3/31/09	Added General Note (F)
DATE	REVISION	
STATE OF HAWAII DEPARTMENT OF TRANSPORTATION HIGHWAYS DIVISION BRIDGE GENERAL NOTES INTERSTATE ROUTE H-1 EXTENSION AND REPAIR OF SCHOOL STREET ON-RAMP RETAINING WALL Project No. H11-01-08 Scale: As Noted Date: Feb., 2009

3/31/09	Revised and/or Added Callouts and Legend
DATE	REVISION
STATE OF HAWAII DEPARTMENT OF TRANSPORTATION HIGHWAYS DIVISION RETAINING WALL REPAIR and EXTENSION EXISTING SITE PLAN INTERSTATE ROUTE H-1 EXTENSION and REPAIR of SCHOOL STREET ON-RAMP RETAINING WALL Project No. H11-01-08	
Scale: As Noted	Date: Feb, 2009
SHEET No. Q3 OF 34 SHEETS

RETAINING WALL REPAIR and EXTENSION

NOTES:

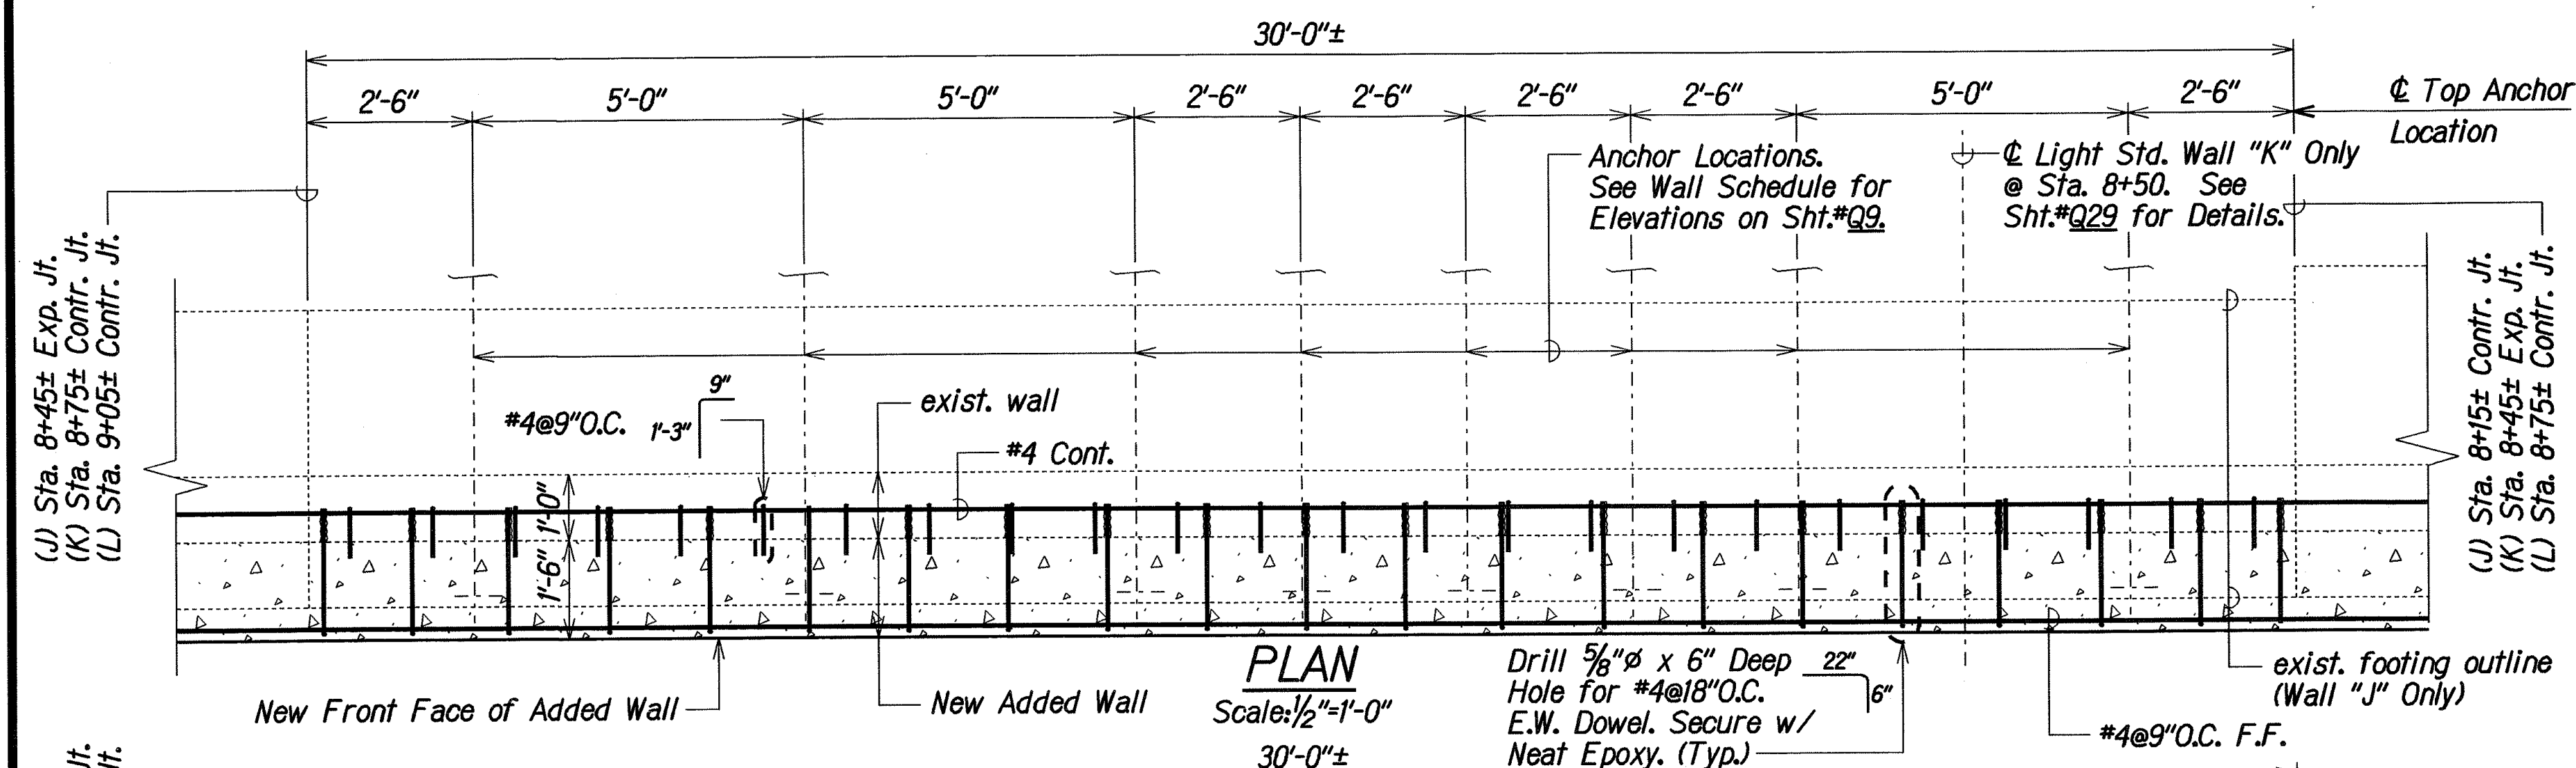
3/31/09	Revised Detail Designation
DATE	REVISION
STATE OF HAWAII DEPARTMENT OF TRANSPORTATION HIGHWAYS DIVISION RETAINING WALL REPAIR WALL "J", "K" AND "L" DETAILS INTERSTATE ROUTE H-1 EXTENSION AND REPAIR OF SCHOOL STREET ON-RAMP RETAINING WALL Project No. H11-01-08	
Scale: As Noted	Date: Feb. 2009
SHEET No. Q20 OF 34 SHEETS

TEST WALL, SCHOOL STREET END POST and WALL "P" DETAILS
REPAIR of SCHOOL STREET ON-RAMP RETAINING WALL

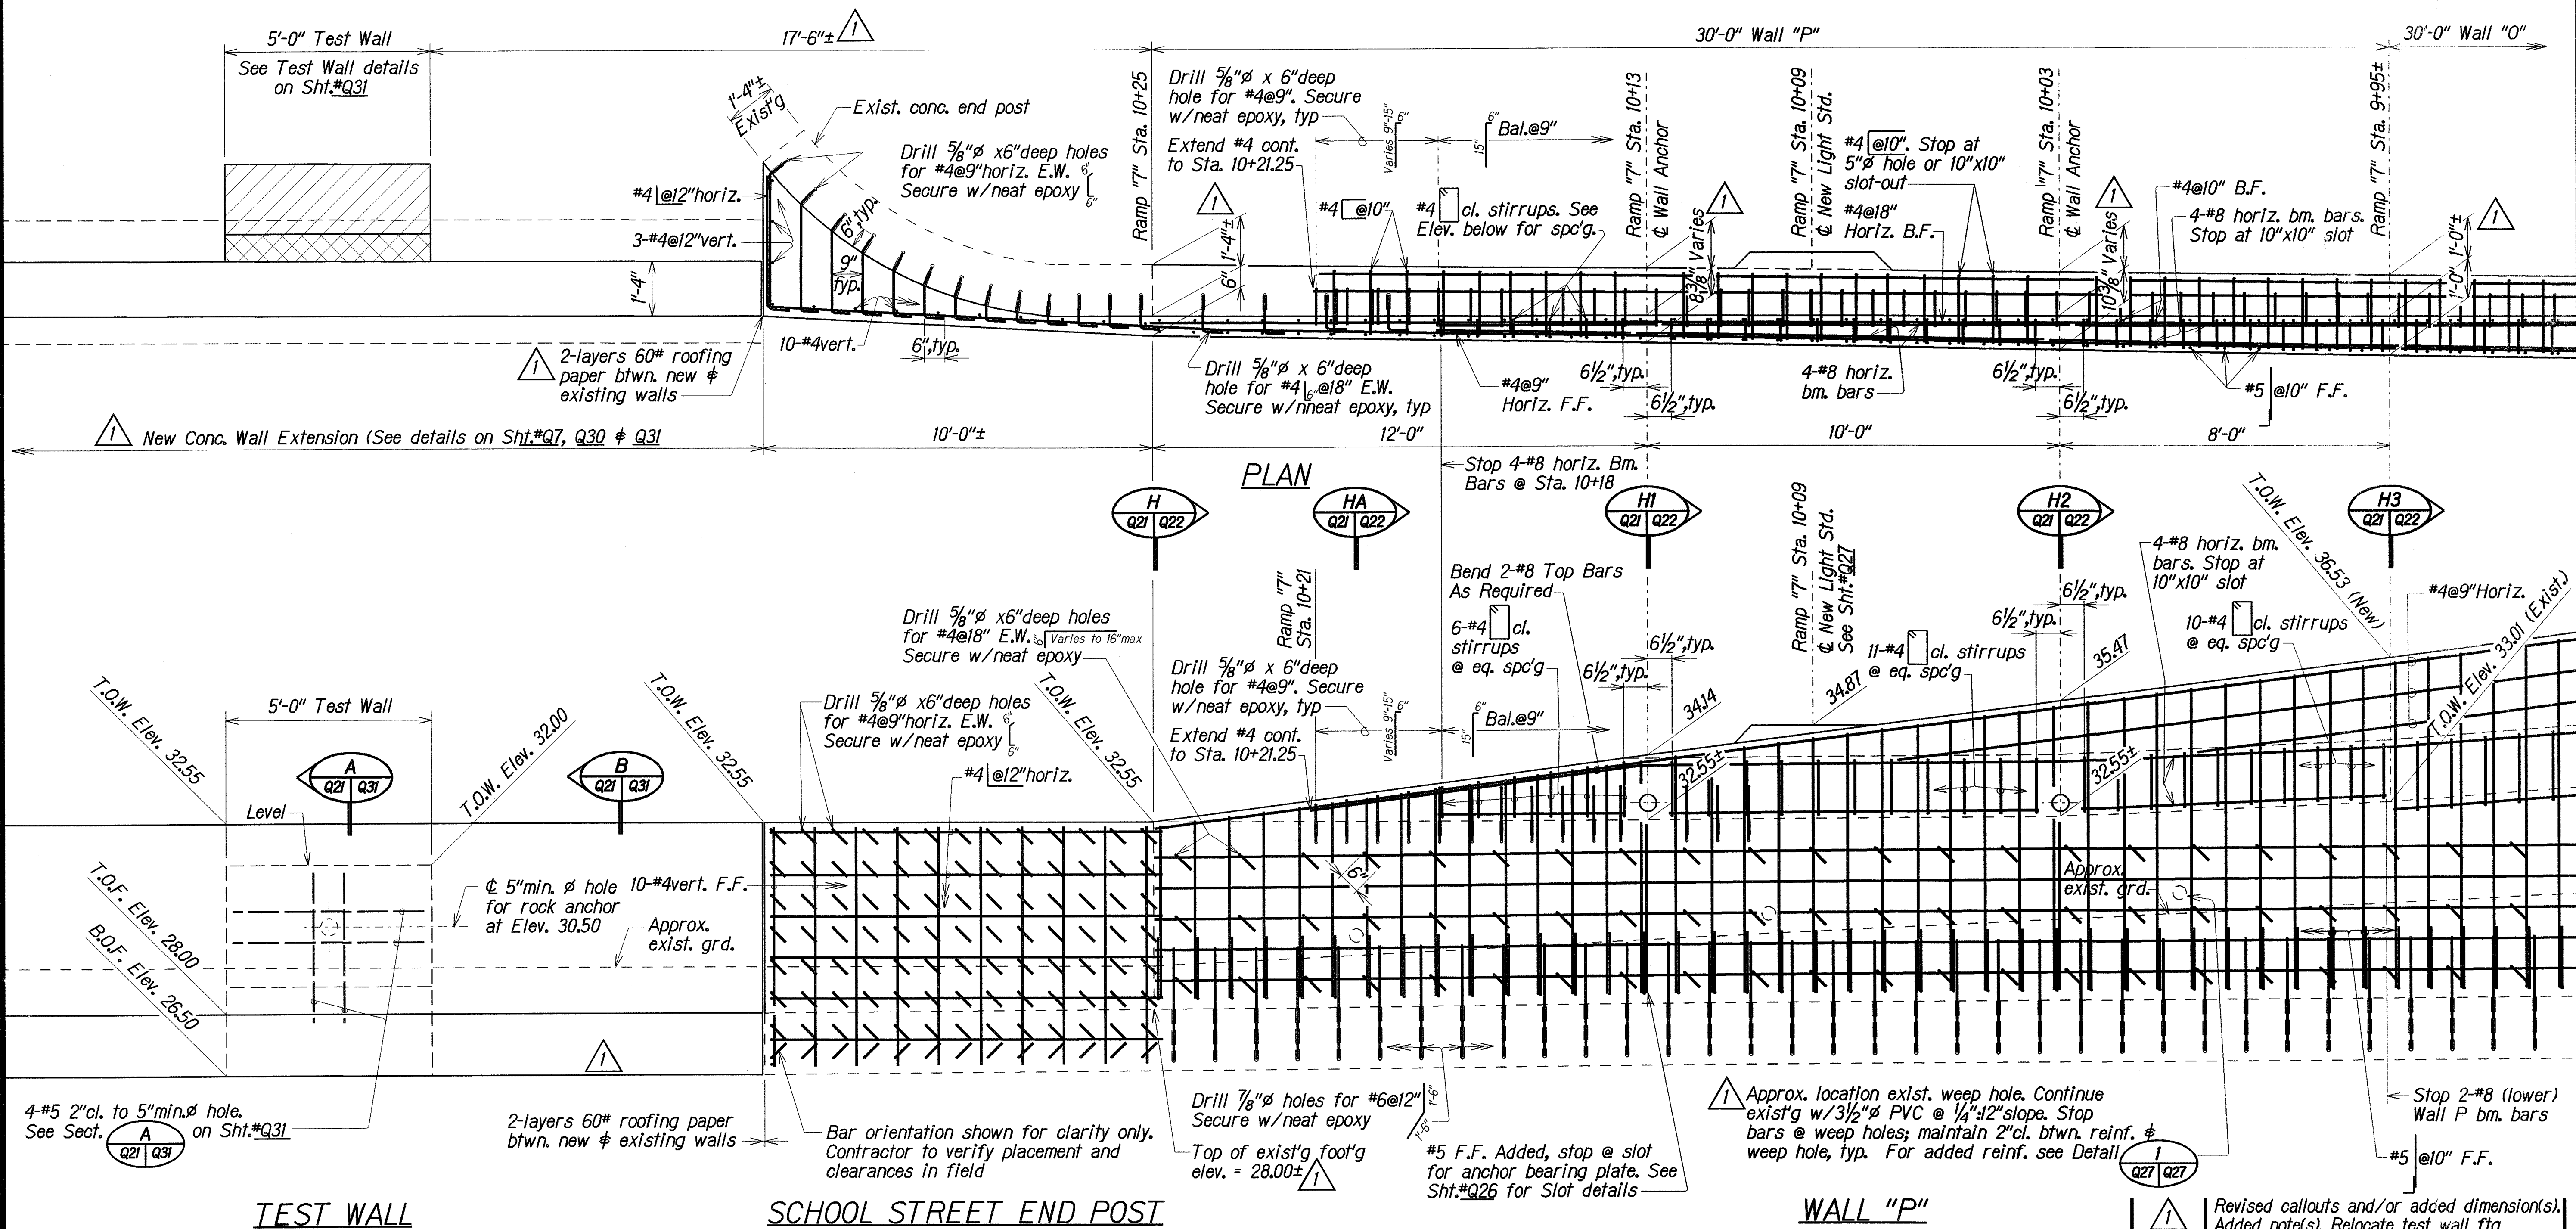
3/31/09	Revised callouts and/or added dimension(s). Added note(s). Relocate test wall ftg. lines. Added legend. Added Sec
DATE	DESCRIPTION
STATE OF HAWAII DEPARTMENT OF TRANSPORTATION HIGHWAYS DIVISION RETAINING WALL REPAIR TEST WALL, SCHOOL ST. END POST and WALL "P" DETAILS INTERSTATE ROUTE H-1 EXTENSION and REPAIR of SCHOOL STREET ON-RAMP RETAINING WALL Project No. H11-01-08	
Scale: As Noted	Date: Feb. 2009
